Independent Power Producer (IPP) Inspection Project Report

Stave Lake and Lamont Hydroelectric Projects

Stokke and Tipella Hydroelectric Projects

Date of inspection: October 30, 2008

Figure 2. Silt fencing along Lamont access road.

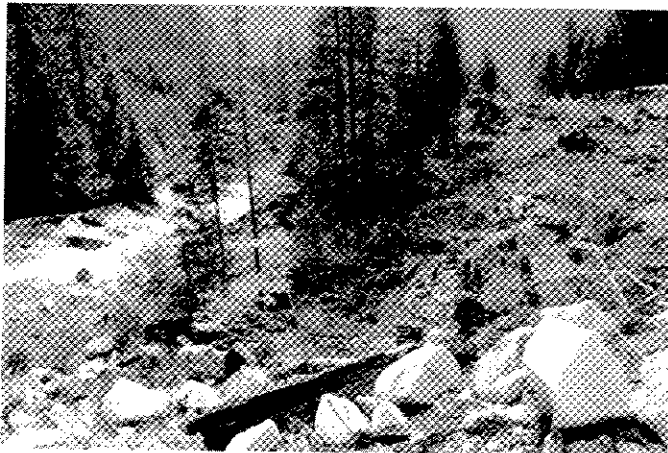
3.2 Lamont: There was over-reliance on silt fencing for erosion control along the Lamont access road. Single row silt fencing should not be the only technique used for erosion control. MOE recommends the use of other techniques to provide additional lines of erosion control (such as depth). The access road and the erosion control works require a shut-down plan for stabilizing the works for winter and spring runoff conditions. (Figure 2; Davies)

Figure 4. Sediment build-up below culvert along the Tipella access road (left), and collapse of bank adjacent to culvert (right).

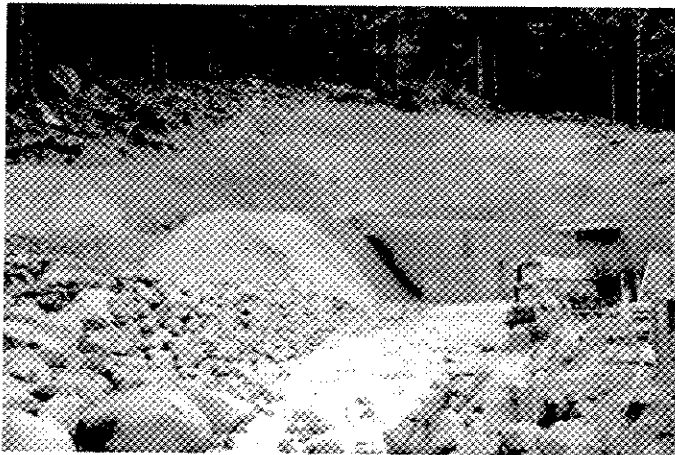
1.4 Tipella: Large amounts of sediment were observed at the discharge point of a culvert along the Tipella access road. The bank surrounding the culvert was not properly armoured, leading to collapse and high amounts of build-up behind the sediment fences. MOE recommended that the bank be properly stabilized, and the sediment build-up be removed to limit discharge into the forest. (Figure 4; Malt)
